DUKE POWER COMPANY

August 7, 1985

Re: Catawba Nuclear Station, Units 1 and 2
Docket Nos. 50-413 and 50-414

Please find enclosed revised pages for the proposed Catawba Units 1 and 2 Technical Specifications. These proposed Technical Specification changes replace the corresponding pages previously included in my March 15, 1985 submittal.

Figure 2 Catawba Unit 2 Reactor Coolant System Cooldown Limitations Applicable up to 16 EFY

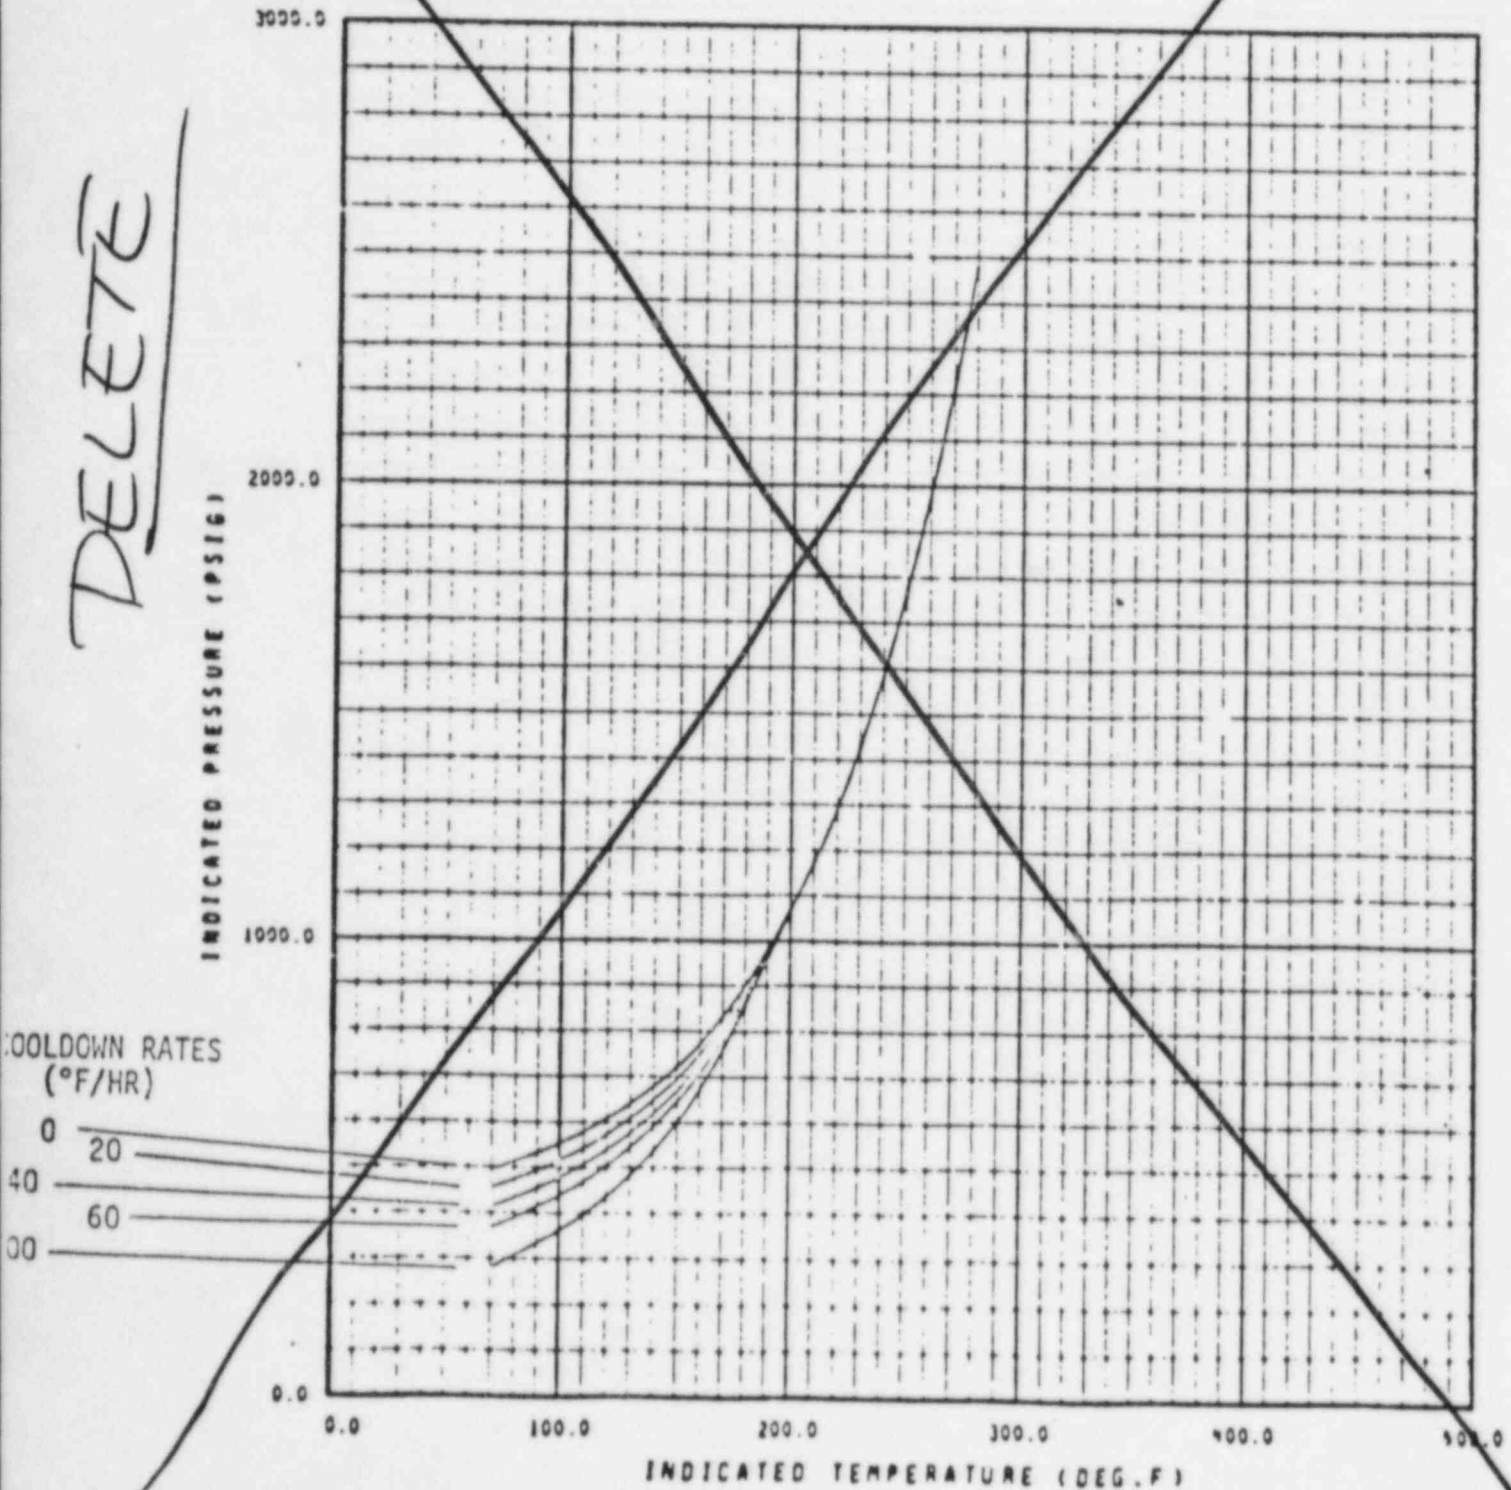
DELETE
